**SUBMISSION TO  
THE LEVEL CROSSING REMOVAL AUTHORITY –  
ESSENDON JUNCTION (BUCKLEY STREET)  
GRADE SEPARATION OPTIONS**

## Attachment 1 – Evaluation of LXRA’s preferred option of ‘Road under Rail’ against the LXRA’s Urban Design Framework

## Attachment 2 – Minimum design improvements Council seeks to reduce negative impacts of the road-under option

Figure 2: Restricted turning movements arising from road-under option

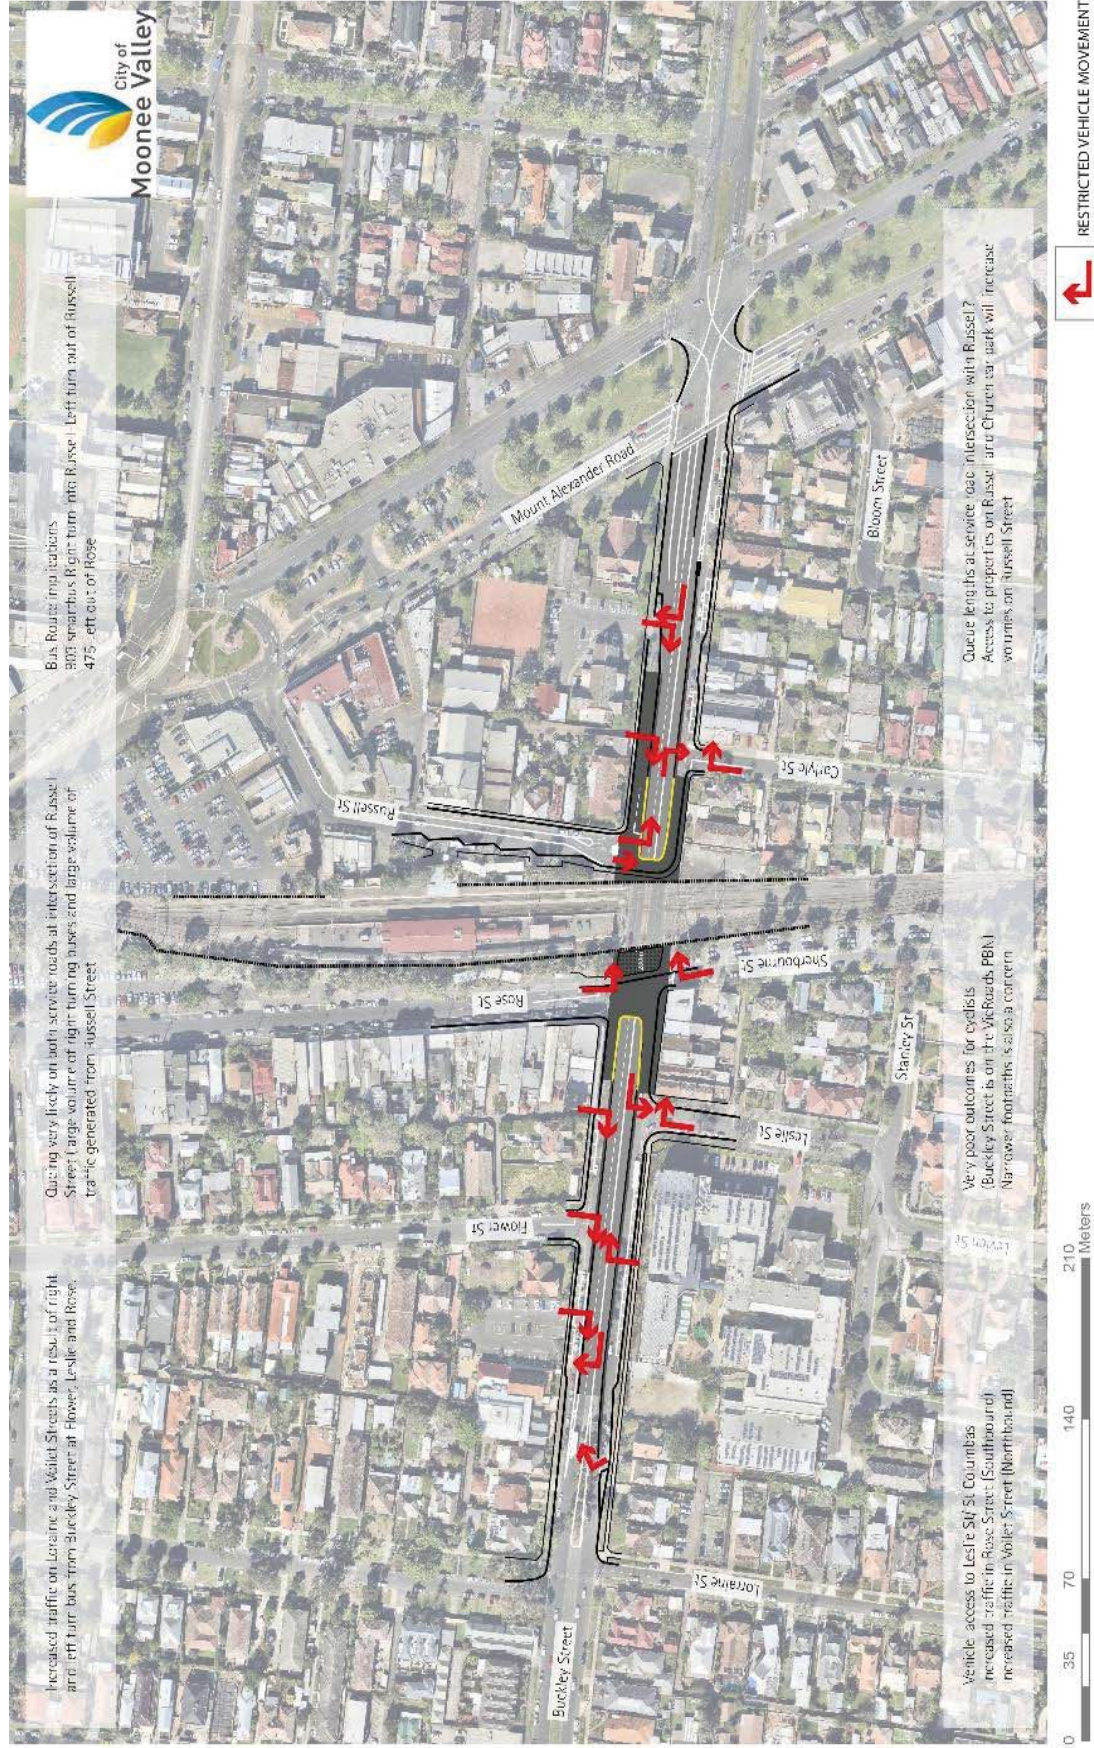
The review of the traffic impacts prepared by O'Brien Traffic demonstrates the local road network will be severely impacted by a road under solution, with the removal of 17 road movements currently available within the 385m extent of the cutting. It is considered the impacts of these movements will be felt strongly by local residents, traders and the school communities within the immediate area.

Figure 2 shows the turn movements that will be restricted by the road-under preferred option.

Figure 3 Inaccuracies in the LXRA consultation image

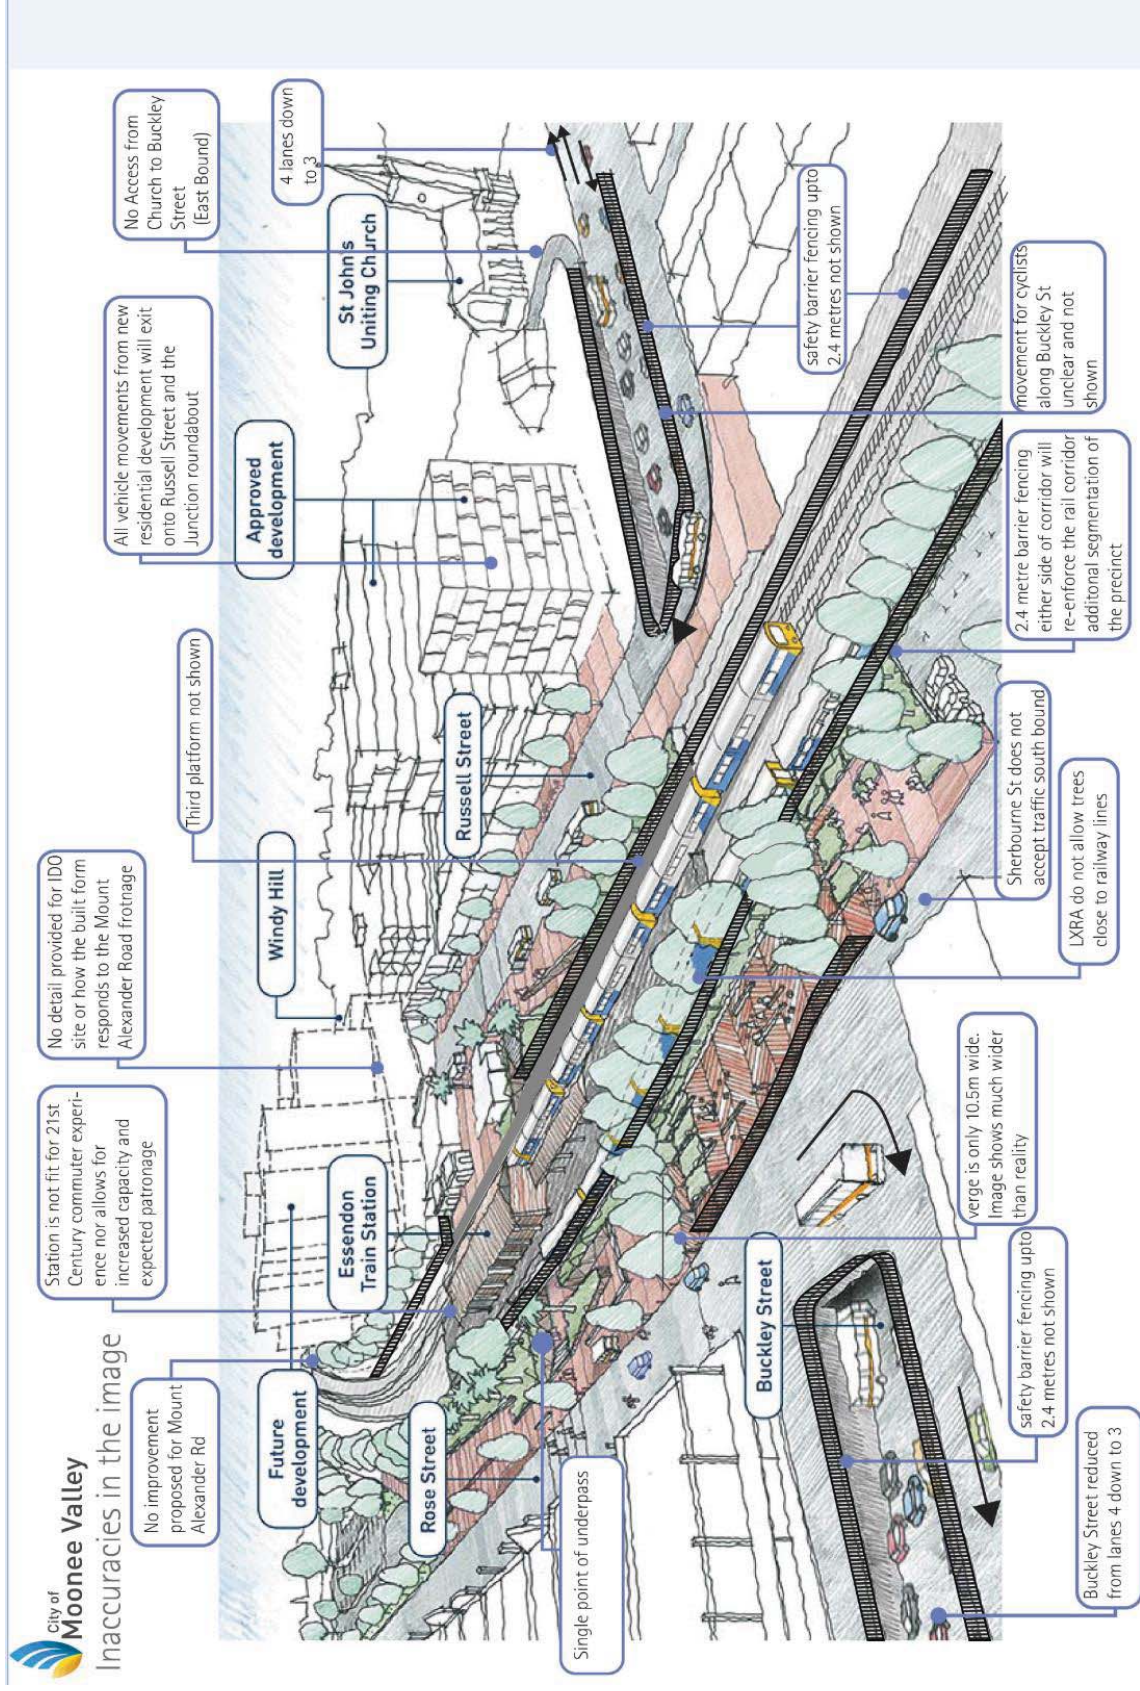
Figure 3, on page 20 presents the inaccuracies in the artist’s impression used at the community consultation in November / December 2016.

6.9 Materials and Finishes	<p>96. Limited detail has been provided to Council regarding proposed materials and finishes to the road trench.</p> <p>97. Council considers the release of an inaccurate artist impression to be a substandard approach to the communication of a design solution when other level crossing options have provided realistic photo montages to inform the debate about options moving forward.</p>

26. The brochure of the preferred option needs to be updated to accurately show both pedestrian and cyclist access through the road trench as well as details of barrier fencing.
